Re: Appeal to Fire and Building Code Enforcement Inspection Report
McDonald's Restaurant, 1000 Smith Ave. Crawfordsville, IN
Dated October 29th, 2015

RE: 1000 SMITH AVE CRAWFORDSVILLE IN
VIOLATION # BU25188

FIRE AND BUILDING CODE ENFORCEMENT INSPECTION REPORT ORDER

CASH BOOTH ADDITION

A1.0

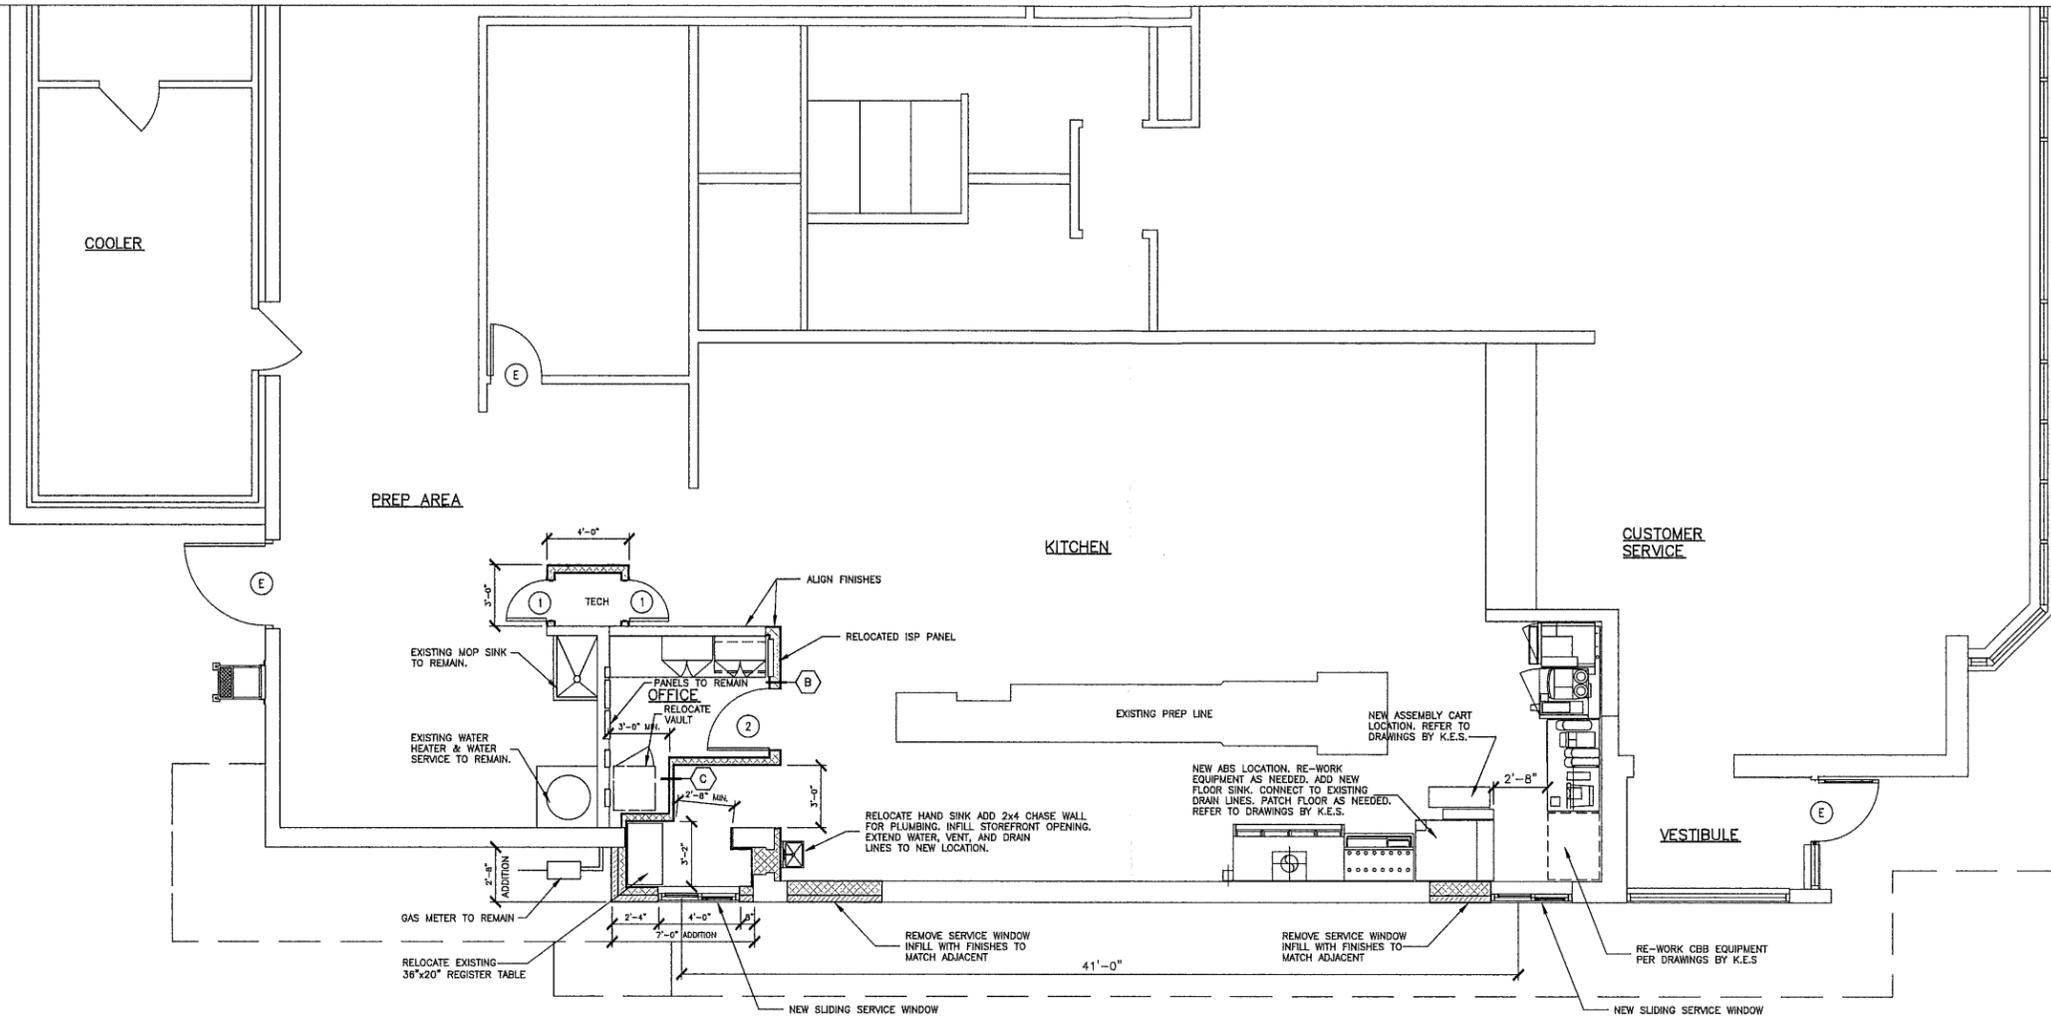
1. The attached letter from a Professional Engineer familiar with the project makes the point that NEC 110.26 (A) provides an exception to service panels that are downstream from the power panels and therefore do not likely to, or require regular examination. The electric panel in question is 120v/1-ph, 200 amp, used only to switch lighting on and off and is fed from the switchgear power panels located in the building.
2. It is also our contention that the panel in question, having the required 36" depth clear for the width of the panel, is within easy arms reach and is fully visible to anyone standing at the safe to access the panels. See attached photo and floor plan that was submitted for Construction Design Release (SBC # 378497) and released June 19, 2015.

VIO-LATION NUMBER	RULE OR INDIANA CODE SECTION VIOLATED	DESCRIPTION OF VIOLATION	DATE BY WHICH VIOLATION MUST BE CORRECTED
1	Sec. 605.3 2014 Edition IFC 675 IAC 22-2.5	A working space of not less than 30 inches (762 mm) in width, 36 inches (914 mm) in depth and 78 inches (1,981 mm) in height shall be provided in front of electrical service equipment. Where the electrical service equipment is wider than 30 inches (762 mm), the working space shall be not less than the width of the equipment. No storage of any materials shall be located within the designated working space. Exceptions: 1. Where other dimensions are required or allowed by NFPA 70. 2. Access openings into attic or underfloor areas, which provide a minimum clear opening of 20 inches (509 mm) by 40 inches (1,016 mm). <u>The safe was located in the required clear space.</u>	11/30/2015

It is in my opinion that 110.26(A) NEC would allow an exception to the "minimum working clearance" in that these panels are set up to provide overcurrent protection to downstream equipment only. They are NOT "regularly" or "likely to require examination, adjustment, servicing, or maintenance while energized".

"Sufficient" access and working space ARE provided as the safe located below the panel does not preclude or prohibit the ability of a workman to examine, adjust service or maintain the equipment when de-energized. See attachment "A".
